CALIFORNIA COASTAL COMMISSION

ADOPTED FINDINGS ON COMBINED CONSISTENCY CERTIFICATION AND COASTAL DEVELOPMENT PERMIT APPLICATION

Application No.: **E-12-005**

Applicant: **Pacific Gas and Electric Company**

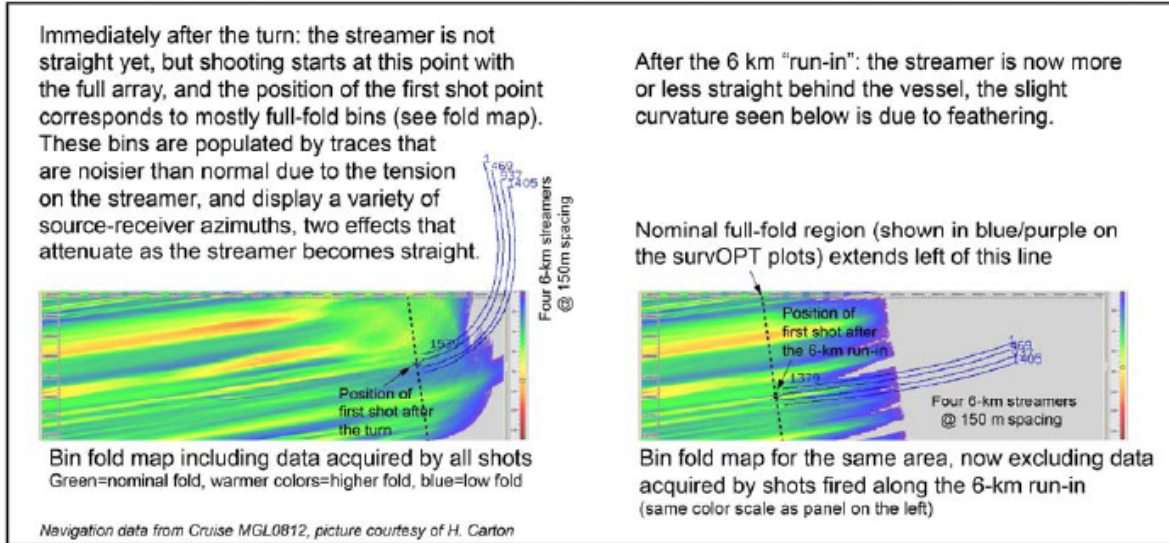
Based on this information, the EIR concluded that noise levels in excess of 154 dB re 1 μ Pa could be considered potentially harmful to recreational divers and swimmers in the project area. Additional studies carried out in 1997 and 1999 (Stevens et al. 1997 and Cudahy et al. 1999) to assist the U.S. Navy in establishing safety thresholds for diver exposure to low frequency active sonar resulted in the Navy setting standard safety protocols that call for the avoidance of all low-frequency active sonar levels above 145 dB in known commercial or recreational dive sites. The studies carried out for the Navy used frequency ranges (100 to 500 Hz) that were substantially lower than those in the table included above and more closely match the dominant frequencies that would be generated by the proposed seismic surveys (0 to 188 Hz). Although no research

has been carried out on human exposure to seismic air gun generated sound, the research carried out for the Navy using low frequency active sonar may be the closest available approximation.
